**From:** [Bob Taunton](#)  
**To:** [Jenah Thornborrow](#); [building](#)  
**Cc:** [JoAnn Butler](#); [Jason Densmer](#); [Doug Russell](#)  
**Subject:** Glass Island View Subdivision - SUBFY2020-6  
**Date:** Tuesday, July 21, 2020 7:47:44 AM  
**Attachments:** [PP-5 Pre Plat Landscape Details - Rev 1.pdf](#)  
[PP-4 Pre Plat Landscape Plan - Rev 1.pdf](#)  
[PP-3 Pre Plat - Rev 1.pdf](#)  
[PP-2 Pre Plat Existing Conditions - Rev 1.pdf](#)

Attached are updated plans for the Glass Island View Subdivision application. The updates are primarily a result of additional survey work and discussions with the immediate neighbours. The attached plans are dated 7-20-20 and include:

**GLASS ISLAND VIEW SUBDIVISION  
PRELIMINARY PLAT**

Revisions  
1. CITY COUNCIL REVS 07-17-20

**PP-2**

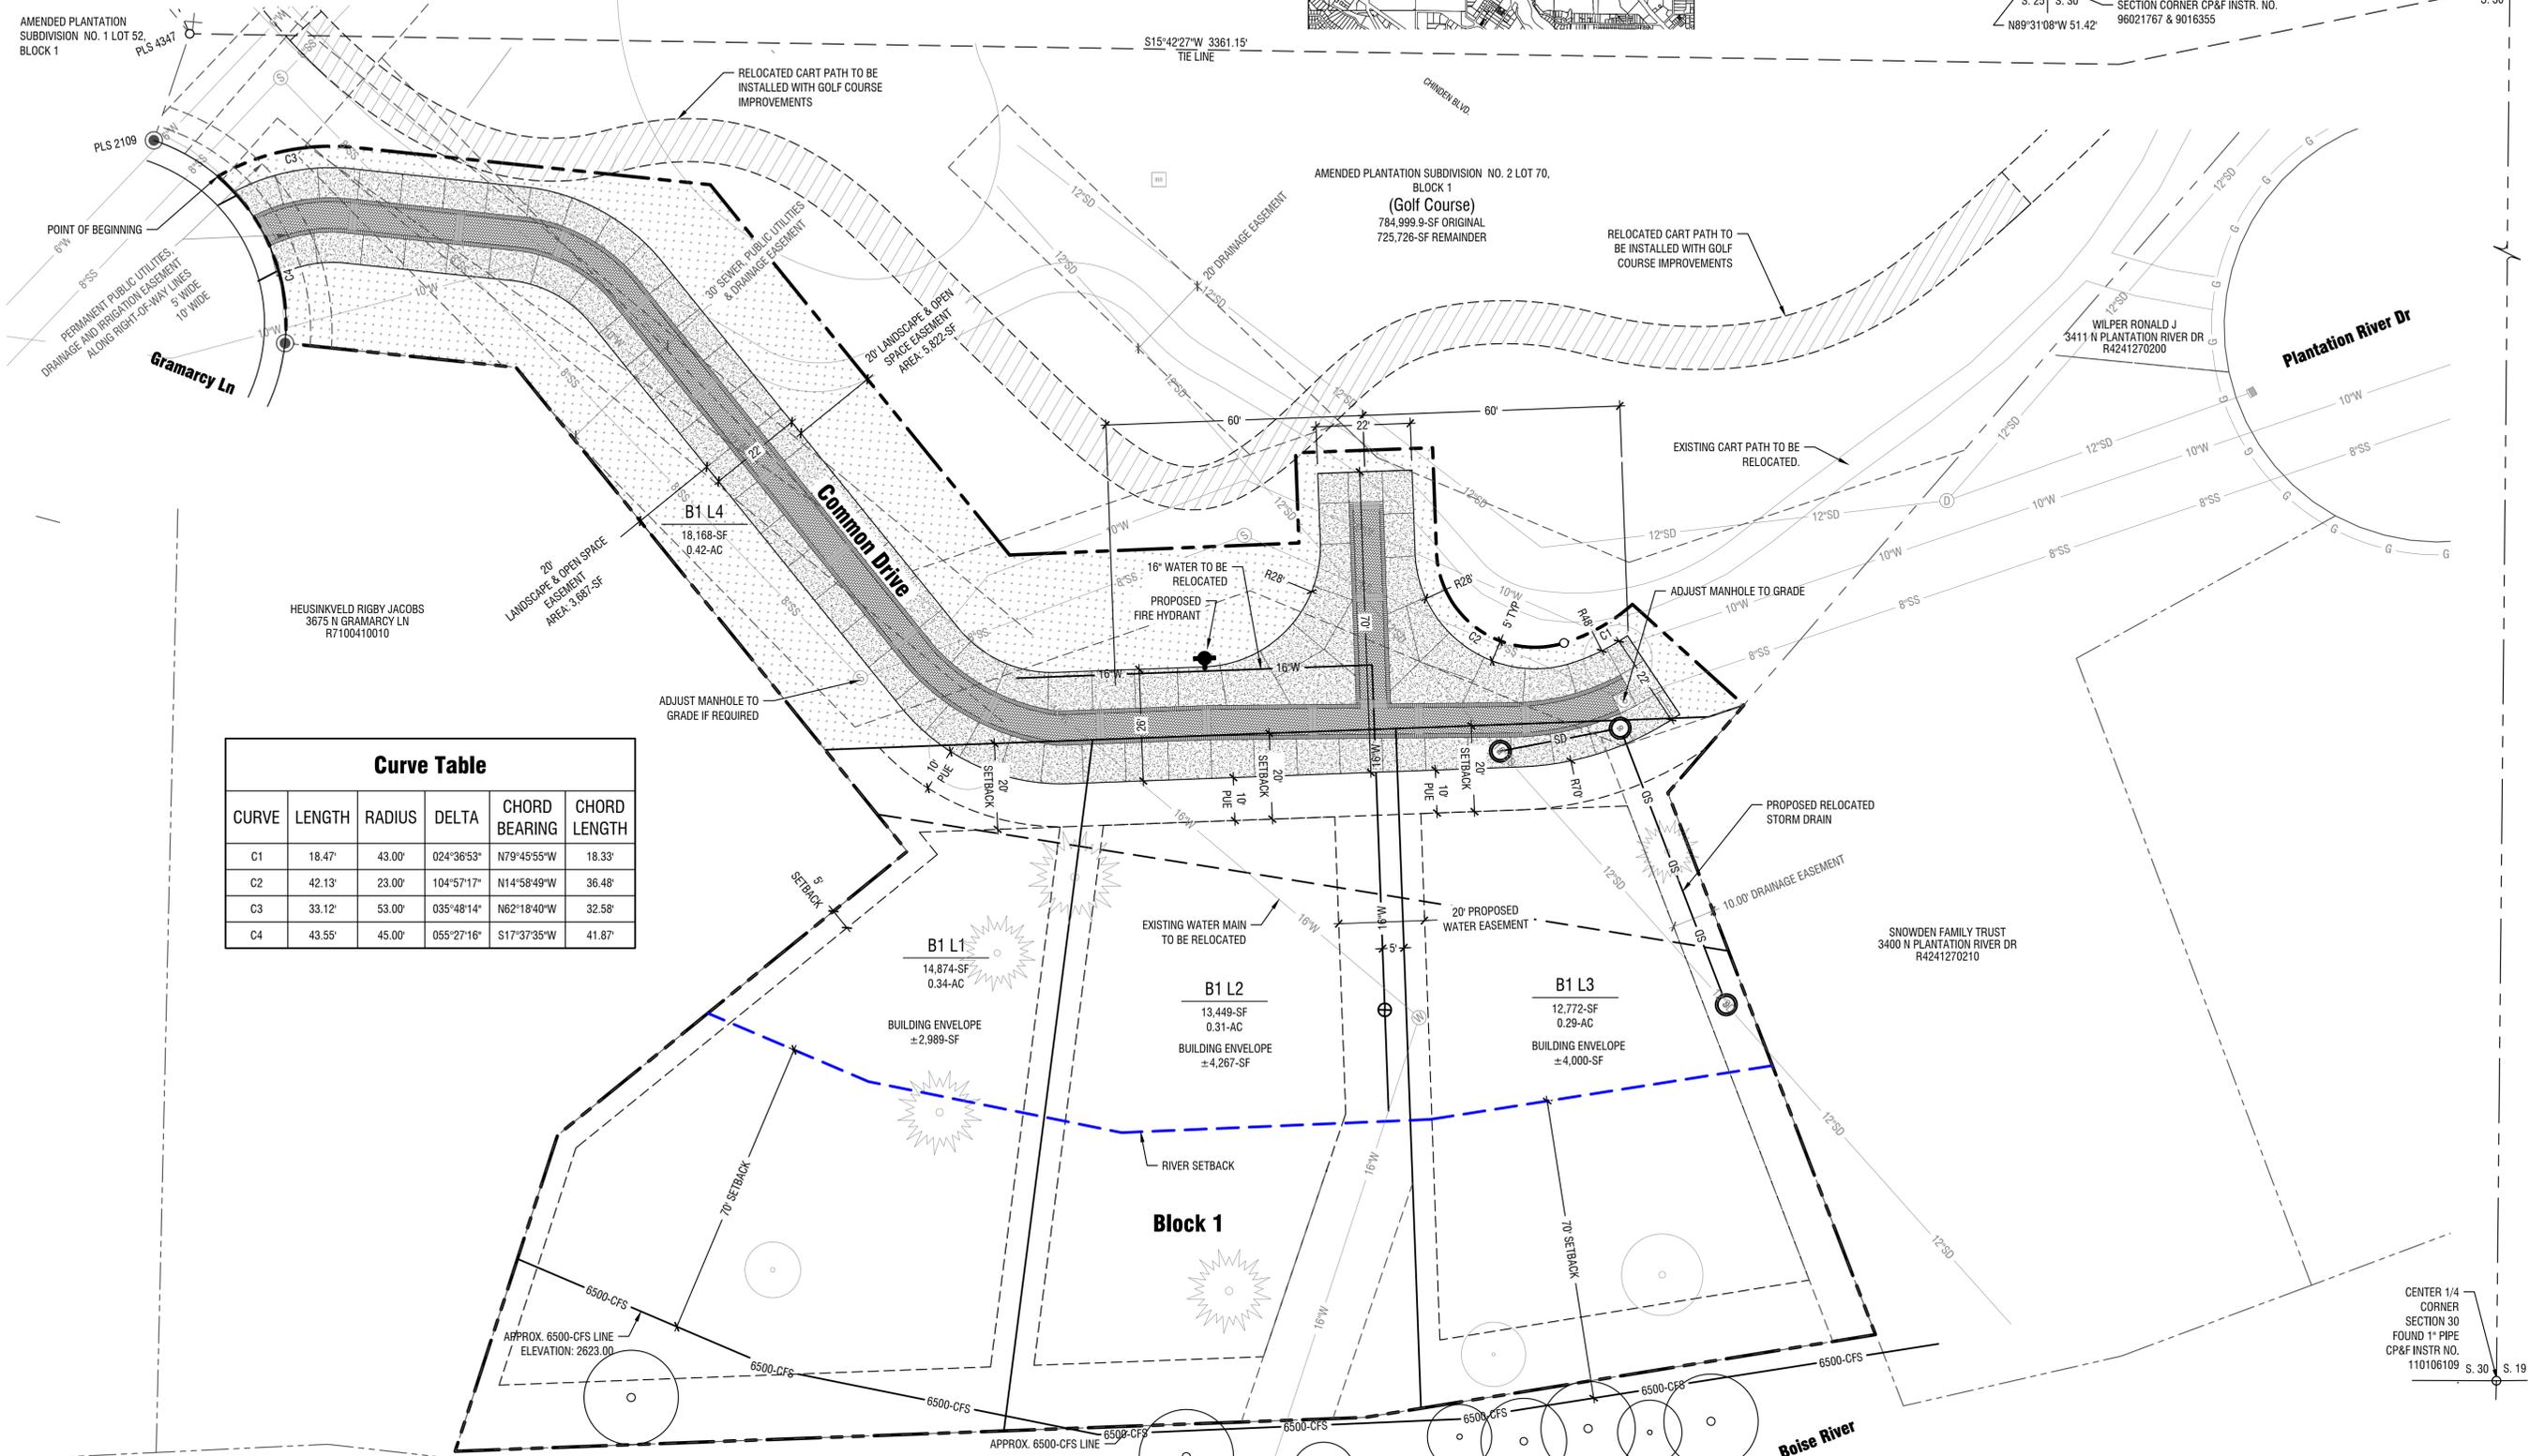
- Revised the 6500 CFS line to the 2623 elevation contour
- Revised the 70' building setback line
- Extended the Lots 1-3 lot lines north to create a 20' front setback including a 10' public utility easement (PUE) south of the shared drive
- Reduced the area of common Lot 4 by including a portion of the shared drive as an easement on Lots 1-3 (refer to Staff report page 18 comment under 8-5A-5 Design Standards)
- Adjusted the width, square footage and building pad size of Lots 1-3
- Reduced the landscaped area slightly and the open space percentage from 16.3% to 16% due to the extended lot line on Lot 1
- Relocated a planned tree adjacent Lot 1
- Removed the proposed 10' public access pathway
